City of Portland, Maine - Building or Use Permit Application
 389 Congress Street, 04101 Tel: (207) 874-8703, Fax: (207) 874-8716

| Permit No: 09-0917 | Issue Date: JAN 11 2010 | CBL: 428 A005001 |

| Location of Construction: 149 Sherwood St | Owner Name: RM, Inc. | Owner Address: 98 Broadway City of Portland | Phone: 207-332-5463 |

| ONE AND TWO FAMILY | PLAN REVIEW | CHECKLIST |

Survey of Land of
149 Sherwood Street
Portland, Maine
for
Rob Twombly

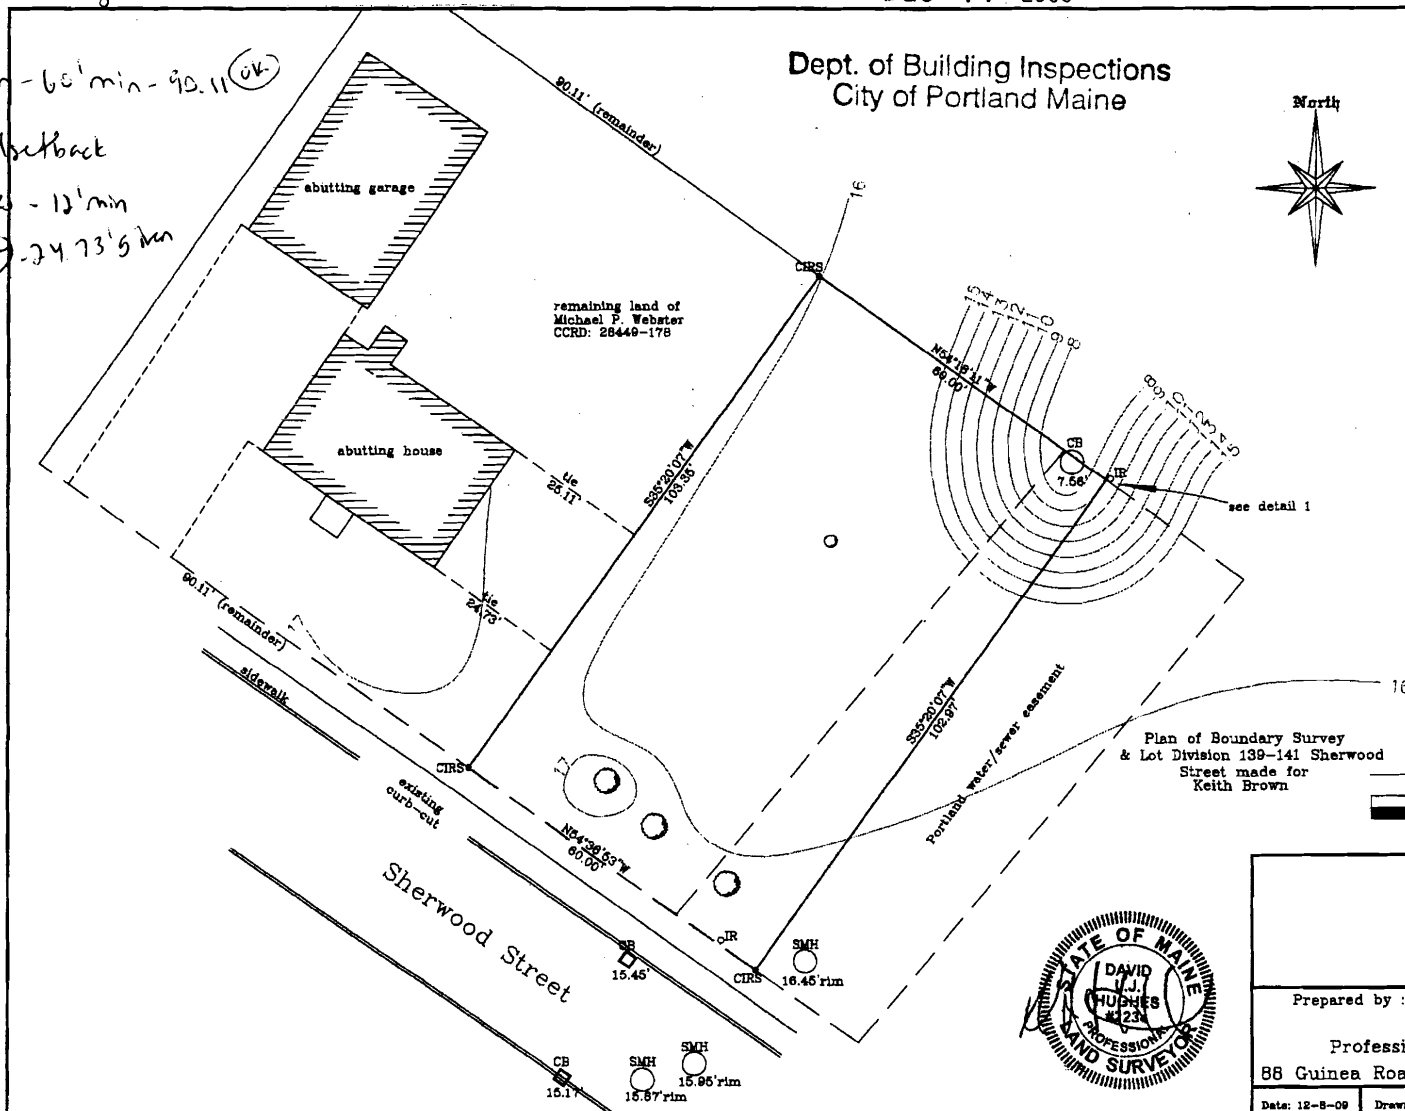
12/17/2009-amachado: Received boundary survey that showed all of original house lot that property was split from. Meets the zoning requirements.

R-5 remaining - original house lot

- lot size - 6,322 ± min - 9312.87 ± (OK)

- street frontage - 50' min - 90.11' (OK)

- lot width - 60' min - 90.11' (OK)

149 SHERWOOD STREET

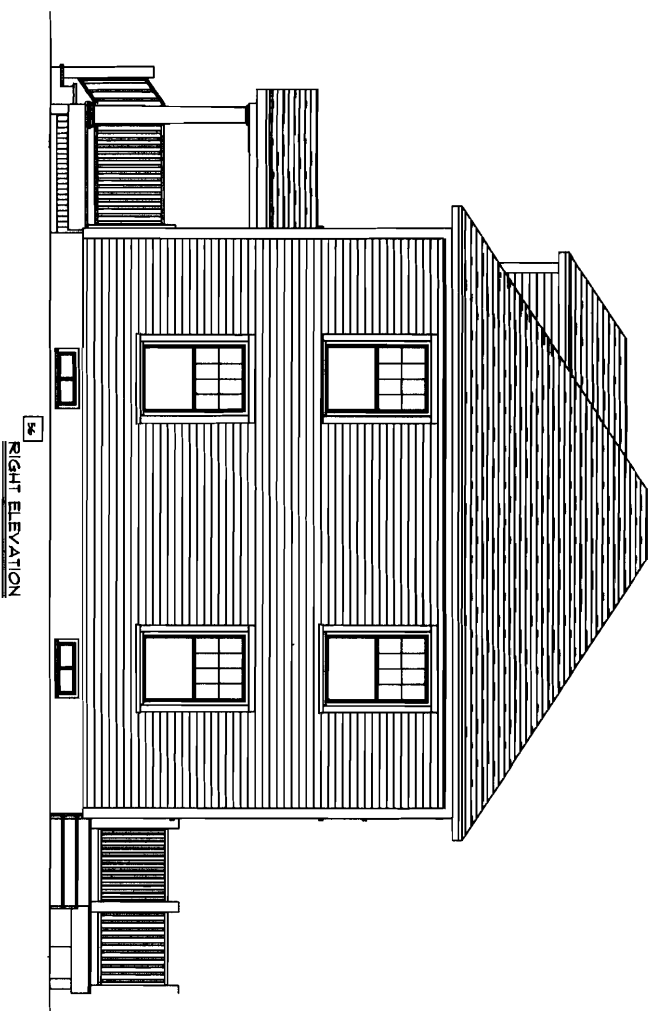
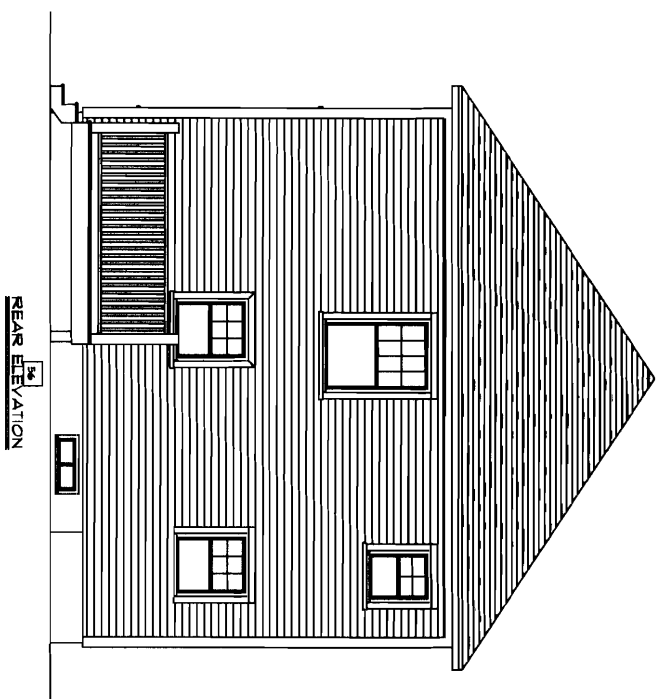
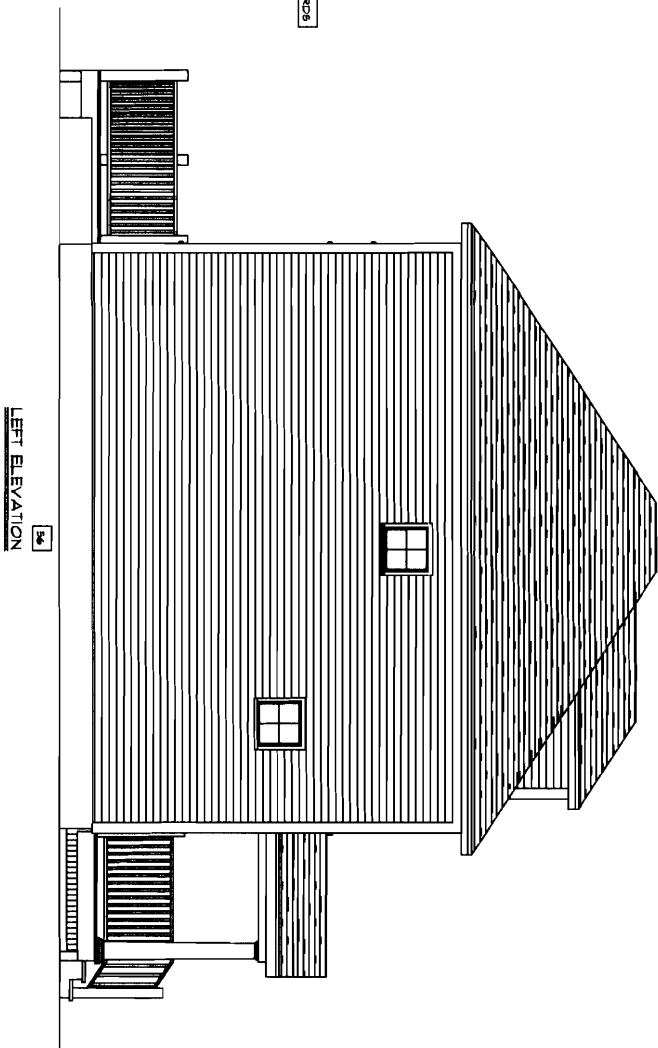
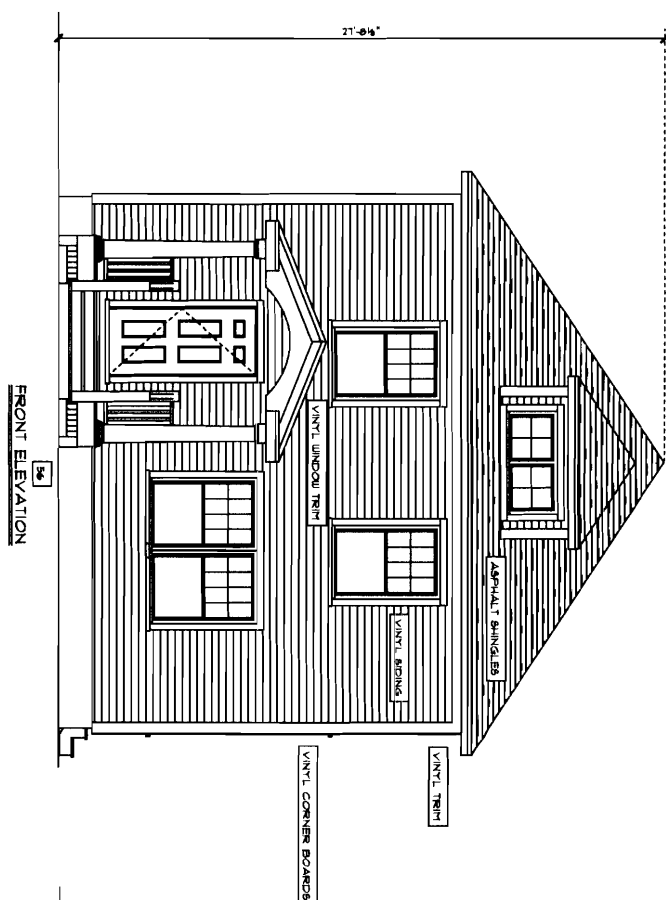
11/30/2009-amachado: Spoke to Rob. Front entry with roof over it is not shown on building plans or siteplan. Waiting to see if Phil needs anything on revised plan. Moved permit forward to Tom Markley, but can't sign off yet.

11/30/2009-tm: called and lm for Ron Twombly that I need plans for new front porch that was added from original plans.

3-2x10's

front + rear
